**State of Alaska**  
**Department of Environmental Conservation**  
**Village Safe Water Program**

Re: Amendment 4  
ITB 22-VSW-UNK-040  
Unalakleet Well House  
ITB Due Date: May 6, 2022 @ 2:00 PM AST

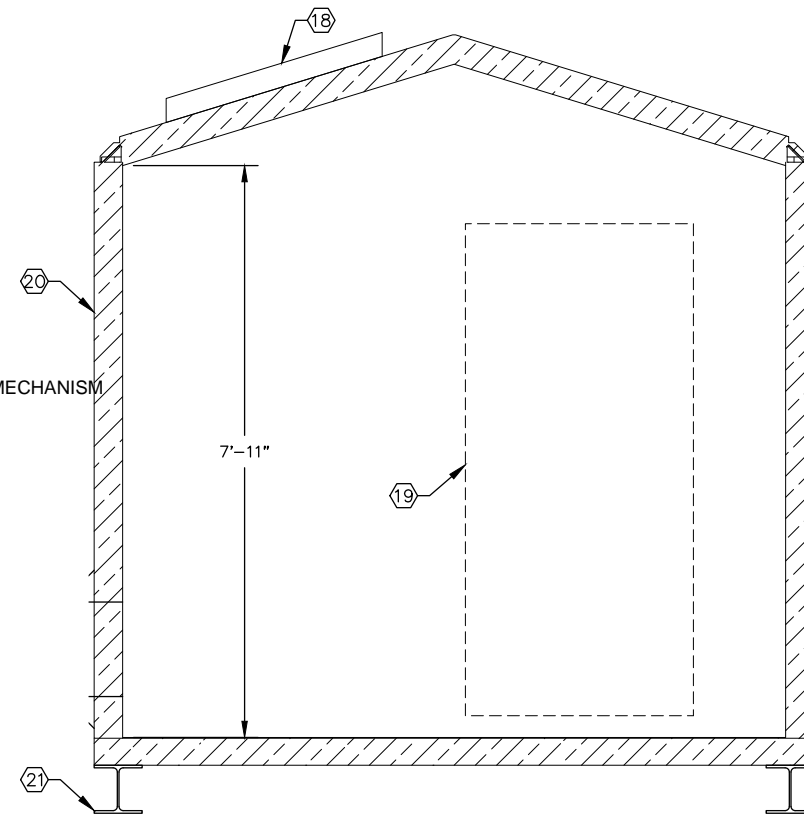
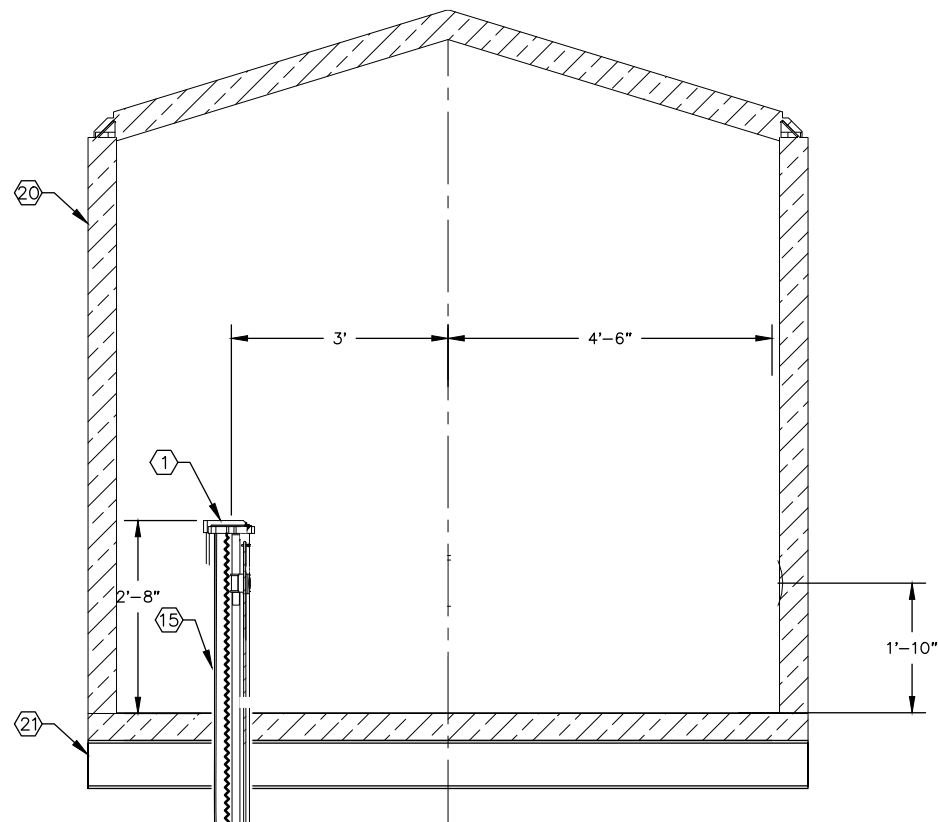
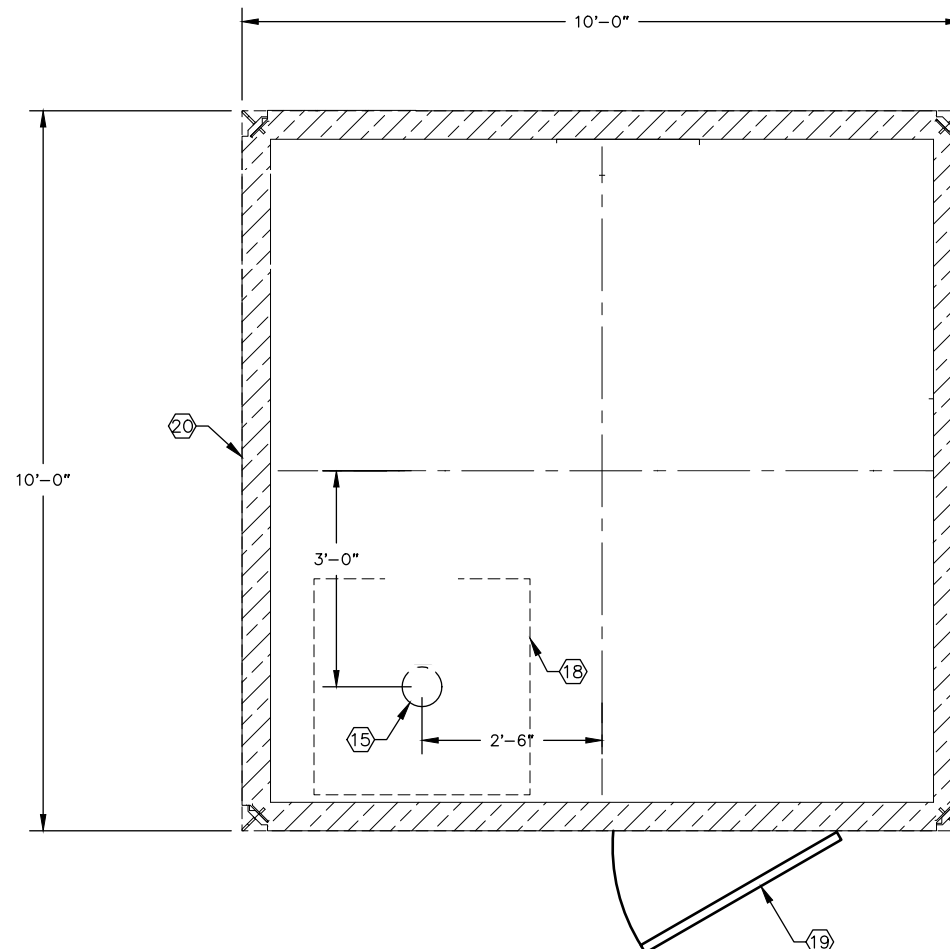
17. Vendor: It appears that only 7 of the drawings were in the link you provided. We still need M-002 which should have the heater details.

Department: Please see attached drawing that pertains to this solicitation.
